ADDENDUM

Project: Wayne State College
Recreation Center/Carlson Natatorium
Fire-Alarm System Upgrade

Addendum No.: 1

AD01.C1-1

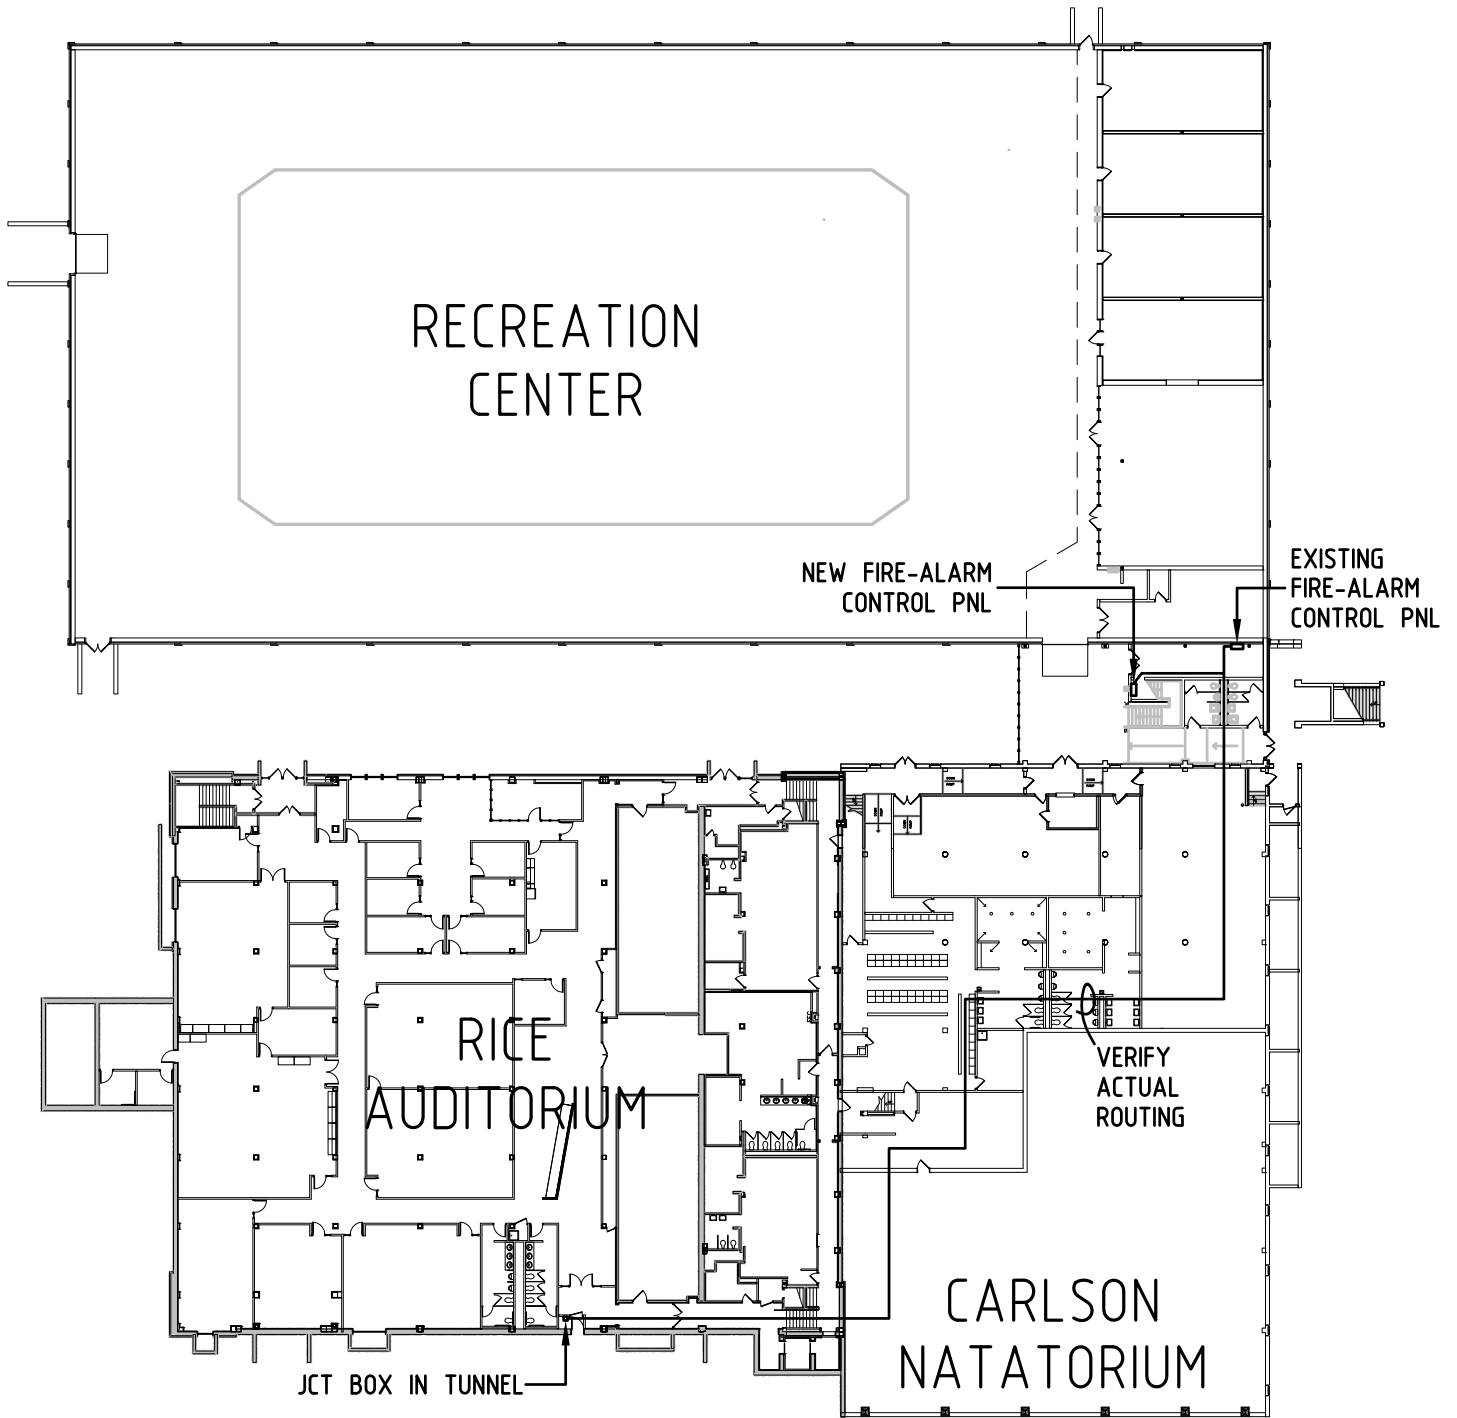
1. Remove existing wire for campus system from j-box in Rice Auditorium tunnel to existing fire-alarm control panel. See attached drawing AD01.C1-1.

-
2. Provide new wire in conduit for campus system from j-box in Rice Auditorium tunnel to new fire-alarm control panel (3-#18/2 in $\frac{3}{4}$ "C - approximately 350'-0"). See attached drawing AD01.C1-1.

AD01.D2-1

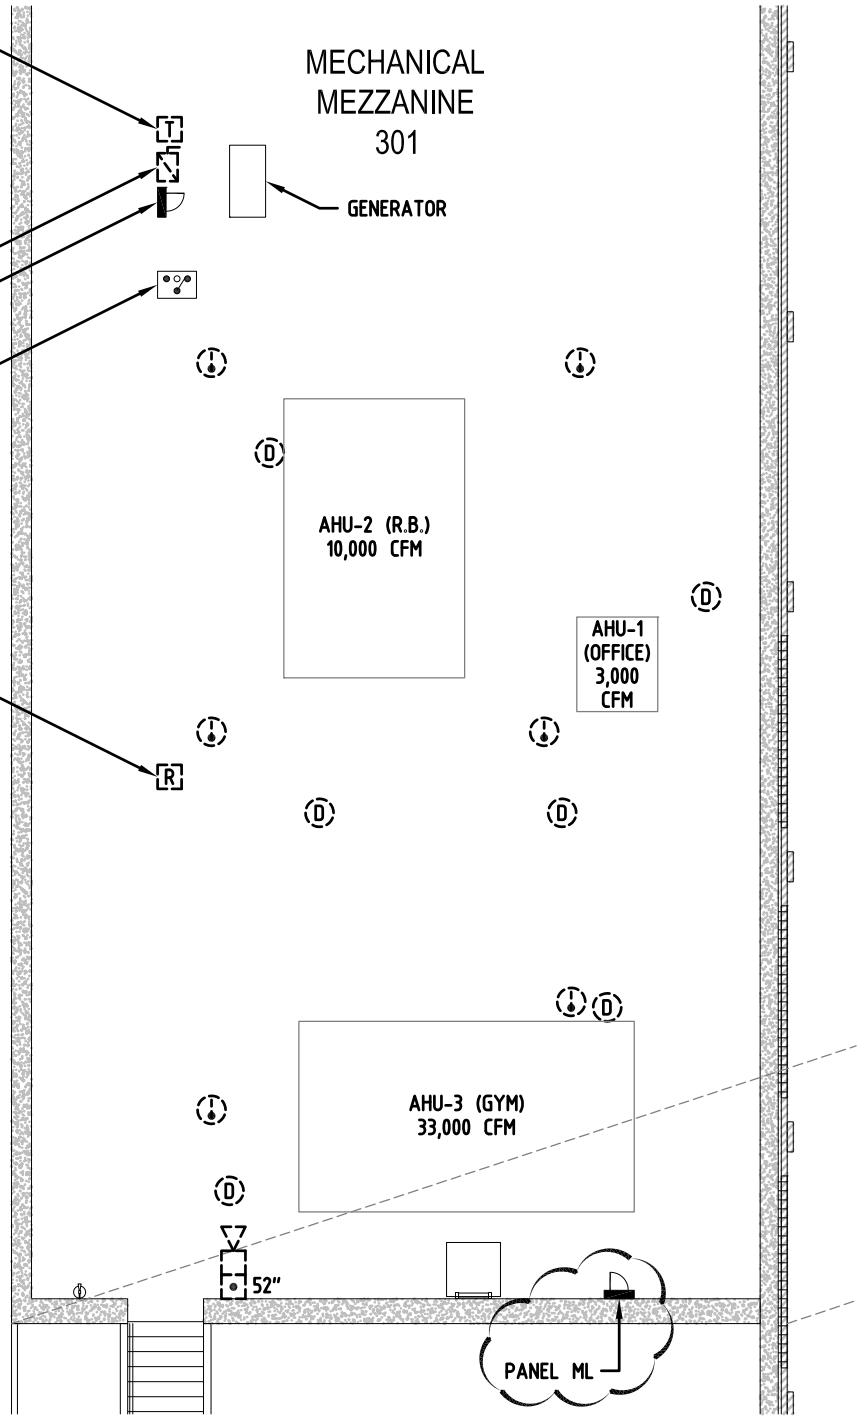
3. Existing fire-alarm control panel is fed from panel 'ML'. Remove 120v branch circuit to source. See attached drawing AD01.D2-1.

AD01.E1-1

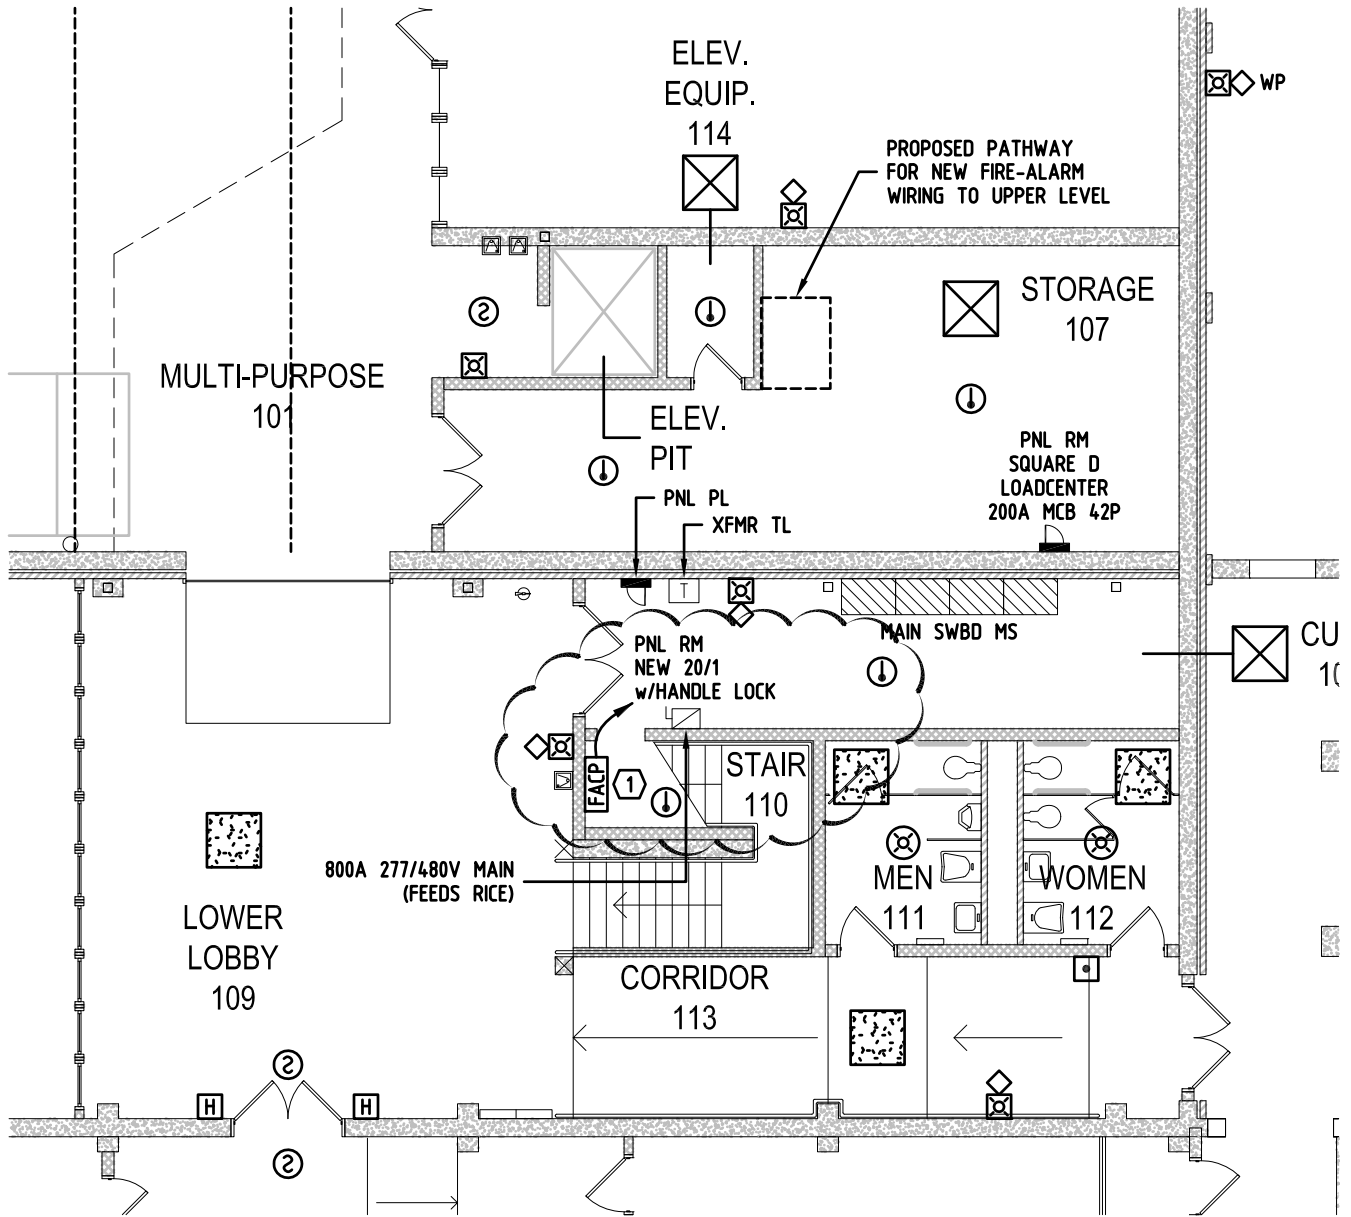
5. Relocate new fire-alarm control panel & heat detector to space under stair 110. See attached drawing AD01.E1-1.
